**From:** Alex Klose  
**Sent:** Friday, December 9, 2022 10:10 AM  
**To:** Jennifer Lindo  
**Subject:** FW: 230 Flanders Road  
**Attachments:** 2002 Connecticut Guidelines for Soil Erosion and Sediment Control - Level Spreaders.pdf; 230 Flanders Road - East Lyme CT - Grading & Drainage Plan (2022-12-05).pdf; 230 Flanders Road - Pond Report.pdf

**From:** Alex Klose  
**Sent:** Monday, December 5, 2022 10:26 AM  
**To:** Gary Goeschel <ggoeschel@eltownhall.com>; Bill Mulholland <billm@eltownhall.com>  
**Cc:** Casey Burch <Casey@sollillc.com>; Anthony Capuano <Anthony@sollillc.com>; Jennifer Lindo <jlindo@eltownhall.com>  
**Subject:** FW: 230 Flanders Road

I reviewed the Wetlands/Zoning application for 230 Flanders Road "Soapy Noble". I asked the applicant's engineer to send me the revised calculation's attached (Jenn please add to the record along with this email) to confirm a couple of questions I had. These will be integrated into the final stormwater report pending either of your comments and/or the commissions' comments.

**Figure LS-1 Minimum Dimensions for Level Spreader**

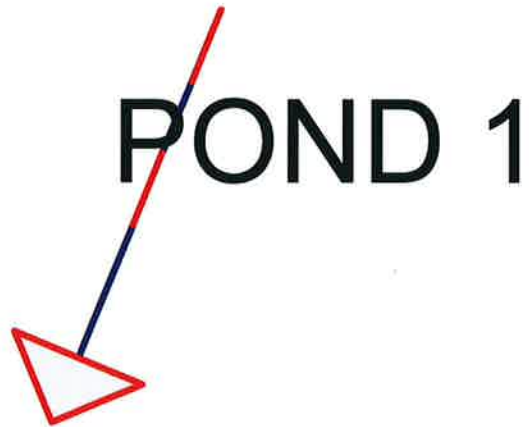
- Revised pond report correcting the culvert from a 12" to a 24" pipe
- Revised grading plan showing correct level spreader dimensions
  - We had previously shown an oversized 20' x 6' level spreader, which has been corrected to 10' x 6'
- Section from the CT SEC guidelines showing that for 0-10 cfs flows, a 10' x 6' x 0.5 deep level spreader is adequately sized
